Site Accessibility Evaluation

Austin Bluffs Open Space

Accessibility Evaluation

SUBJECT: Austin Bluffs Open Space Self-Evaluation

Finding: 1

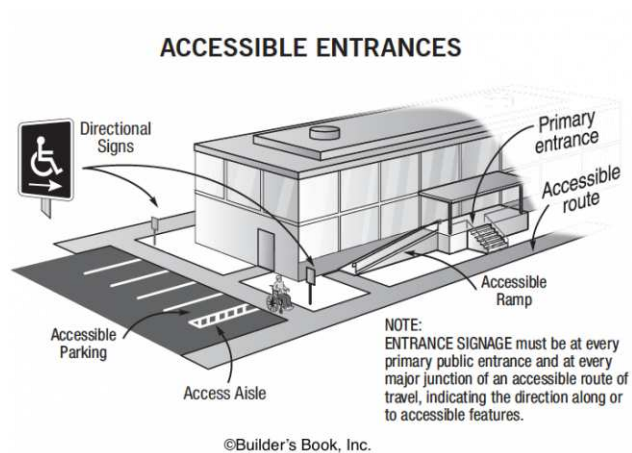
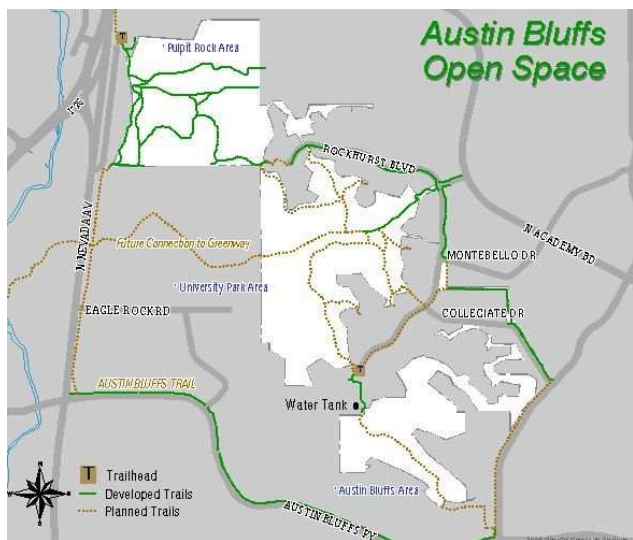
There is no accessible route to Pulpit Rock or other natural features.

The open space lacks accessible trails. The main trail entrance is off of Rockhurst and is in a natural state.

Do nothing for now. Not everywhere needs to be accessible. We need to focus on what is feasible or not materially alter the nature of the facility or experience.

Finding: 3

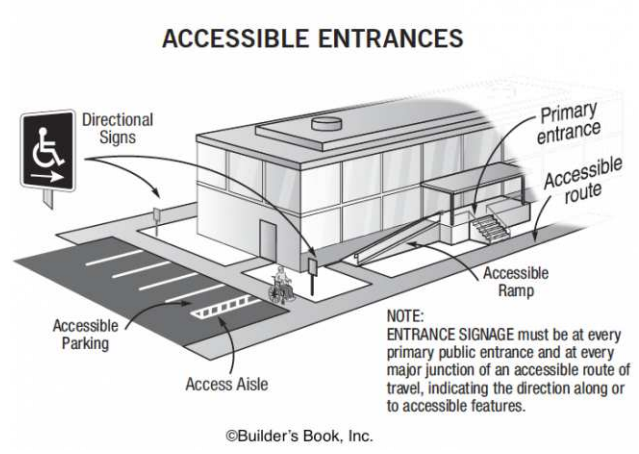
There is no accessible route of travel from the public way.

The northernmost public entrance off North Nevada is a natural dirt/rock surface and has no accessible entrance. This is fine as we have no amenities here and this entrance is for hiking up to Pulpit Rock and other natural areas in the open space.

Do nothing at this time. If and when we add amenities we need to add an accessible route.
